Site Address
Resource Consent Number
Flux Reviewed

Rangitopu Development Riverhead, Auckland
BUN00449727
Stormwater Management Plan Rev A, Main Date: 30 April 25
Appendix A1.3 Stormwater Downpipe, Main
Flux Assessment Report: Main, Rev A, Date: 5 May 2025

Model Review Comments

Figure 2 - RFM Rangitoto Water Level TS

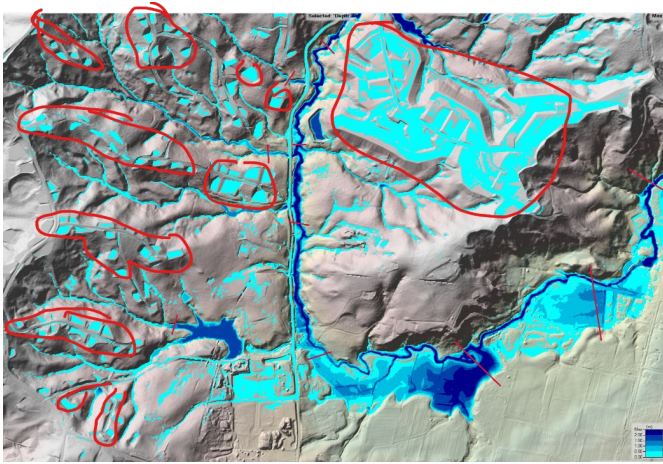
6	Downstream model boundary condition	A constant water level of 2.55m has been adopted at the junction with the Rangitopu River. Regional Rate Road Flood Model indicates an elevated tail water during extreme events. Suggest the TS from the RRM to be used as a dynamic boundary condition.	Figure 2 and Tab DS VLS TS	Downstream boundary can impact flood levels at Riverhead	Confirming Main will use a 500-year model with the dynamic heights of the downstream boundary condition. The results of this will be shared with Healthy Waters as soon as these are available. We remain of the view, that this scenario is not critical, as absolute values downstream should not be a key concern, if our model continues to confirm the reduction in peak run-off, which will deliver downstream benefits irrespective of the boundary condition modelled.	Additional Modelling was completed and sent through on the 23/10/25 investigating the effects of the using the provided dynamic height downstream boundary condition. Model confirmed that dynamic boundary did not have any effect on the peak flows and assessment.

Figure 3 - Post Development CN Number - Infiltration layer

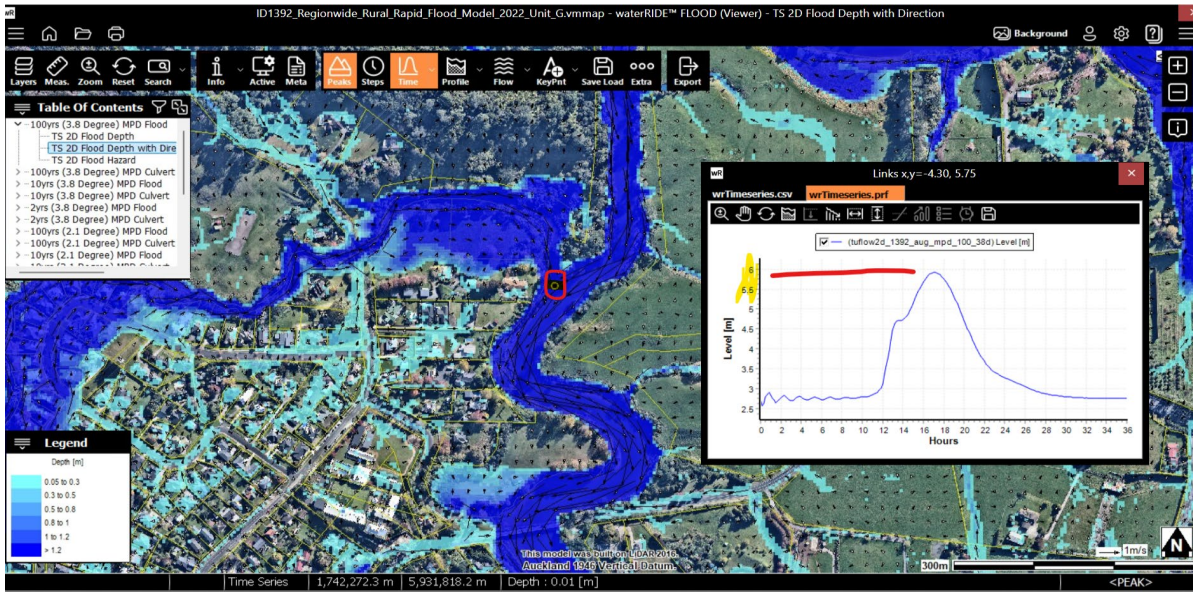
8	Post development CN Number	There is no calculation and GIS file supporting the derivation of the composite CN number for each infiltration type polygon. The converted bush area will be in the range of 15% and will take a very long time to establish. Therefore there will be a long time during and after the development, where the represented bush area will not be established. The increased flood risk during this period should also be assessed. The timing of the artwork, housing development and native bush establishment should be provided to enable a clear understanding of this intermediate risk.	Figure 3	Assessment of effects from development requires appropriate representation of the post development condition	Mayor's position remains that the pre-development assessment is based on a conservative CN of 74, which we are of the view that the current CN should be 77. As such, we feel that this allows for the transition period where the bush is establishing. Given that modelling is based on long term probabilities, we still feel that the approach is the best for the catchment. If this is an issue, we are open to introducing some interim mitigation which would use on-site attenuation of roof and/or driveway areas being proposed. However, we do not believe that this is required for property and would suggest that such controls would only be required for the first few years, or until canopy cover is achieved in the planted areas. We are happy to discuss how this could be considered, if this is an approach that we need to take. We are of the view, that this would only need to be considered for the eastern catchment.	Mayor's position remains that the pre-development assessment is based on a conservative CN of 74, which we are of the view that the current CN should be 77. As such, we feel that this allows for the transition period where the bush is establishing. Given that modelling is based on long term probabilities, we still feel that the approach is the best for the catchment. If this is an issue, we are open to introducing some interim mitigation which would use on-site attenuation of roof and/or driveway areas being proposed. However, we do not believe that this is required for property and would suggest that such controls would only be required for the first few years, or until canopy cover is achieved in the planted areas. We are happy to discuss how this could be considered, if this is an approach that we need to take. We are of the view, that this would only need to be considered for the eastern catchment.

Figure 4 - Culverts Proposed - Not in the HEC-RAS Model

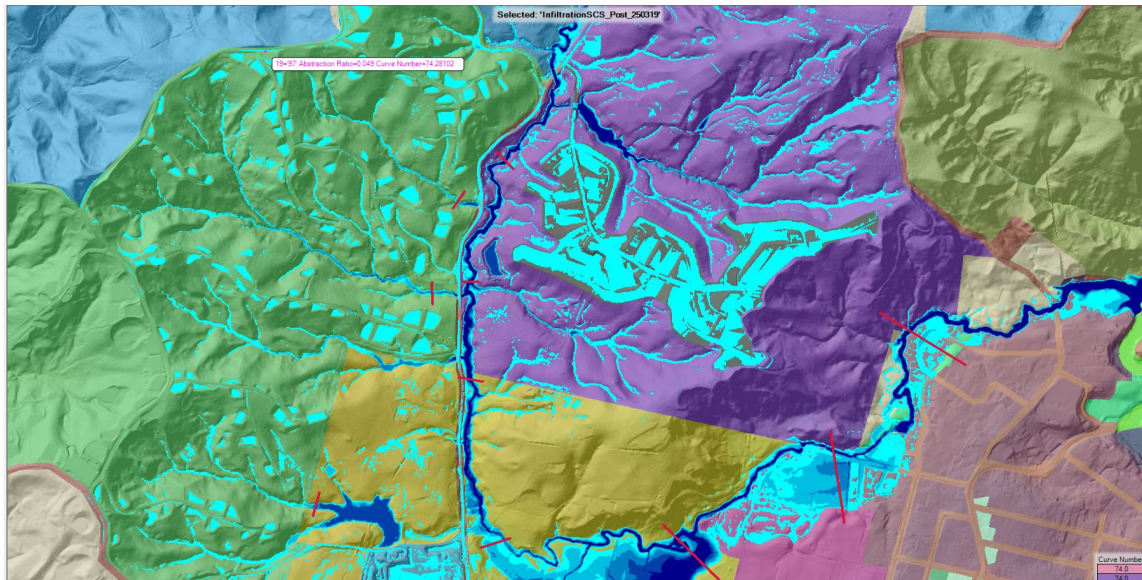
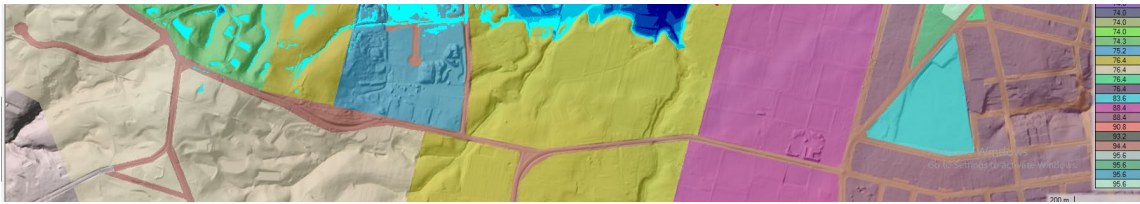
11	Representation of Culverts proposed in the model	There are at least five very large culverts proposed which are not found in the HEC-RAS Model, either in Figure 4 - Please explain.	Figure 4	Correct representation of all culverts proposed	These culverts have been added to the model. (Downstream catchment model still containing minor updates and will be made available tomorrow)	Additional Modelling was completed and sent through on the 23/10/25 and 23/10/25 with additional culverts added. Two of the mentioned culverts were located in the Western catchment and three in the eastern catchment. Updated model included Culverts 1-5, 1-6, 4-6 and updated culvert 2 to 1.5m x 1.5m box shape culvert addition of culvert 6-6, 1-6, 13-6 results in peak flow of cross section 6 (figure below) increase of 0.3m from 145.48m to 145.78m, the peak flow is initially 495.84 m/s to 496.84 m/s below development (496.84 m/s).

Figure 6- Culvert 3 size

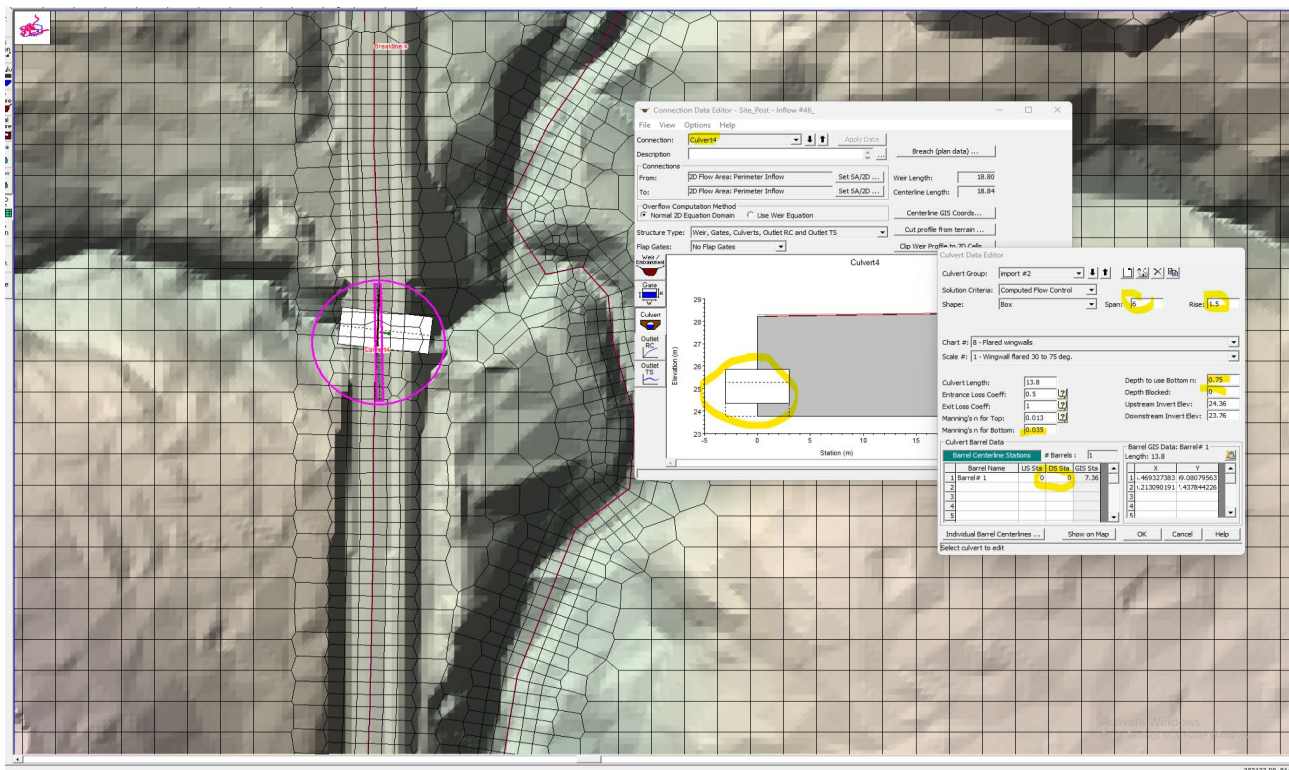
15	Culvert size inconsistencies	Culvert 3 is 4m x 2m in the report, 4m x 2m in the report and plans. Invert levels don't match.	Figure 6	Culvert size inconsistency	Culverts 3 size is 4m x 2m (path 0.5m embankment). Modelled culvert 3 is 4m x 2m (path 0.5m embankment). Modelled culvert in HEC RAS model does not include the embankment depth to avoid software error, so this is why there is a difference in size between HEC Model and the design plans. But this accounts for the embankment depth and details in the standard cross-section drawings.	Culverts 3 size is 4m x 2m (path 0.5m embankment). Modelled culvert in HEC RAS model does not include the embankment depth to avoid software error, so this is why there is a difference in size between HEC Model and the design plans. But this accounts for the embankment depth and details in the standard cross-section drawings.
16	Culvert size inconsistencies	Culvert 2 is 1.5m Dia culvert, but a 1.5m Dia culvert on plan. Invert levels don't match.	Figure 7	Culvert size inconsistency	Culverts 2 size is 1.5m x 2m (path 0.5m embankment). Modelled culvert 2 is 1.5m x 2m (path 0.5m embankment). Modelled culvert in HEC RAS model does not include the embankment depth to avoid software error, so this is why there is a difference in size between HEC Model and the design plans. But this accounts for the embankment depth and details in the standard cross-section drawings.	Culverts 2 size is 1.5m x 2m (path 0.5m embankment). Modelled culvert in HEC RAS model does not include the embankment depth to avoid software error, so this is why there is a difference in size between HEC Model and the design plans. But this accounts for the embankment depth and details in the standard cross-section drawings.

Figure 9- culvert 6

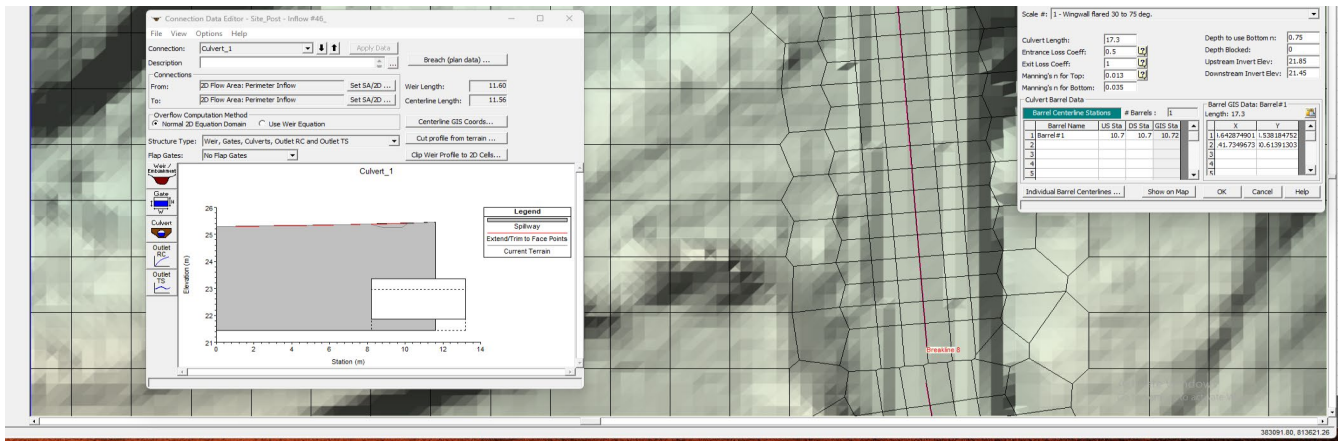
17	Culvert size inconsistencies	Culvert 6 is 2m x 1m in the report, 1.5m x 1.5m in the model and on the design plans. Invert levels don't match between design and model. Please explain.	Figure 9 and Figure 4	Culvert size inconsistency	Culverts 6 size is 1.5m x 2m (path 0.5m embankment). We have updated this to be a box culvert not 1500mm round. Modelled culvert in HEC RAS model does not include the embankment depth to avoid software error.	Culverts 6 size is 1.5m x 2m (path 0.5m embankment). We have updated this to be a box culvert not 1500mm round. Modelled culvert in HEC RAS model does not include the embankment depth to avoid software error.
18	Culvert size inconsistencies	Culvert 1 is 5m x 2m in the report, 5m x 2m in the model and 4m x 2m on the design plans. Invert levels don't match between design and model. Please explain.	Figure 8	Culvert size inconsistency	Culverts 1 size is 5m x 2m (path 0.5m embankment). Modelled culvert in HEC RAS model does not include the embankment depth to avoid software error.	Culverts 1 size is 5m x 2m (path 0.5m embankment). Modelled culvert in HEC RAS model does not include the embankment depth to avoid software error.

Figure 12
No Outlet from dry detention Pond

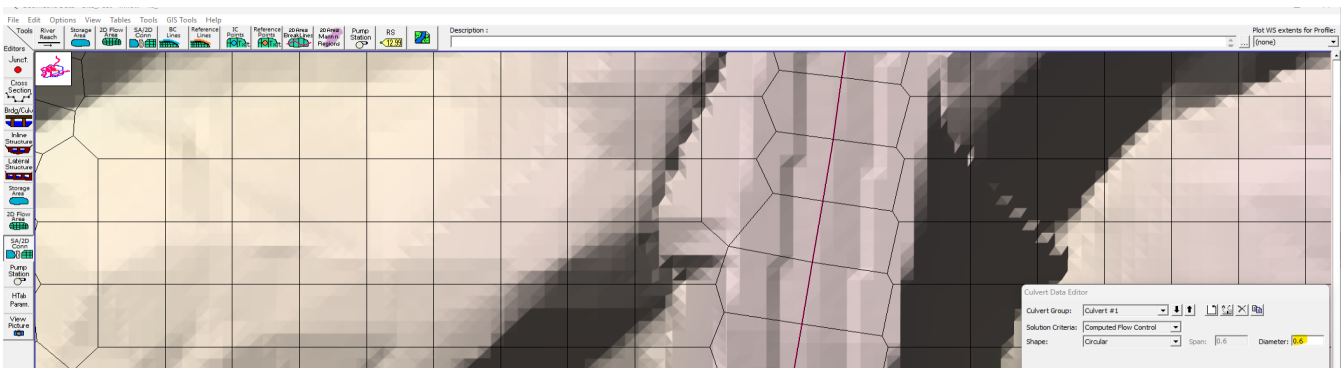
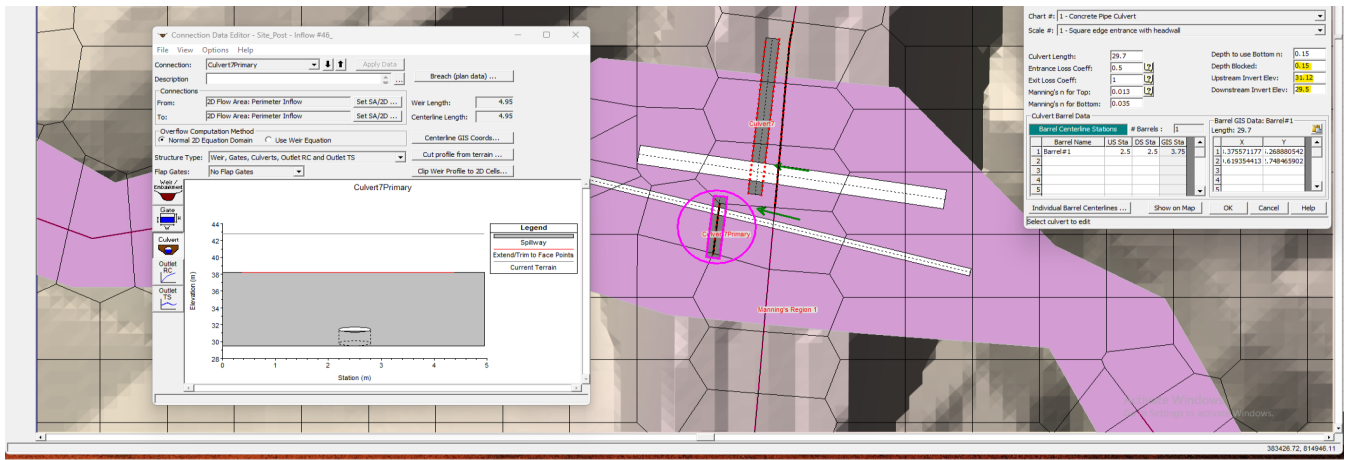
19	On Detention Pond modelling	No outlet included for the dry detention pond. Please clarify how is the detention represented. Any initial water pool?	Figure 12	Correct modeling of dry detention pond	Outlet not included in 100yr model as assumed to be fully blocked. No initial water level with pond base at nRL 32.0.	Outlet not included in 100yr model as assumed to be fully blocked. No initial water level with pond base at nRL 32.0.
20	Terrain and Structure representation issues	Duke Road Bridge not included, and DTM errors in stream corridor require verifications	Figure 16	Model representation of terrain and structures	Confirming Phase will run a 100-yr model with the features included in the pre and post model. We endeavour to do this before Wednesday's meeting. We remain of the view, that this scenario is not critical, as absolute levels downstream should not be a key concern. If our model continues to outline the reduction in peak run-off, which will deliver downstream benefits.	Additional Modelling was completed and sent through on the 22/10/25 with downstream structures listed in Item 20, 21 and 22. Provided sensitivity check model confirmed that the downstream structures did not have any effect on the peak flows. Confirming mentioned downstream structures have no effect on relative water levels.

Screenshot of proposed bridge terrain modification replacting 2.6m existing culvert

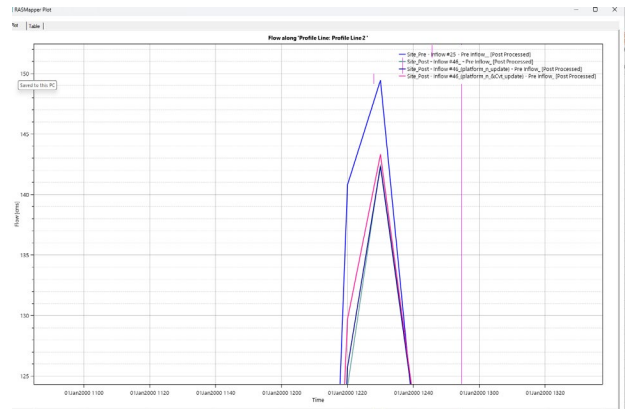
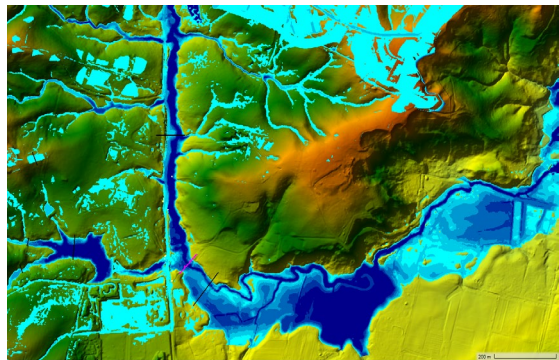
12	Culverts representation inconsistencies	The 2.6m culvert under Deacon Road near the junction with Link Road is included in the pre-development model but not in the post development model. Please explain.		Correct representation of existing culvert	The 2.6m culvert is proposed to be upgraded to a bridge. Proposed development terrain modification has been used to model the reclaimed stream beneath the bridge. Refer to excel sheet "Response sheet 2". We note that this is consistent in all post-development scenarios modelled.	The 2.6m culvert under Deacon Road is proposed to be upgraded to a bridge. Proposed development terrain modification has been used to model the reclaimed stream beneath the bridge. Refer to excel sheet "Response sheet 2". We note that this is consistent in all post-development scenarios modelled.
13	Culverts representation inconsistencies	Culverts 1 to 7 in the post development model. Are there any existing culverts at the locations of Culverts 1-7 under the pre-development condition? Please explain.		Correct representation of existing culvert	The pre-development model does not include any of the existing culverts under Forestry Road, due to their condition and size. All existing culverts are listed under Appendix A of the flood modelling report. The largest culvert under Forestry Road (all of which have been surveyed) is 450mm. As such, given the existing state (poor condition and some retention barriers), and also ensure that the model is correctly represented with them being blocked. This also ensures that the pre-development state includes backwater effects to the west of Forestry Road.	The pre-development model does not include any of the existing culverts under Forestry Road, due to their condition and size. All existing culverts are listed under Appendix A of the flood modelling report. The largest culvert under Forestry Road (all of which have been surveyed) is 450mm. As such, given the existing state (poor condition and some retention barriers), and also ensure that the model is correctly represented with them being blocked. This also ensures that the pre-development state includes backwater effects to the west of Forestry Road.
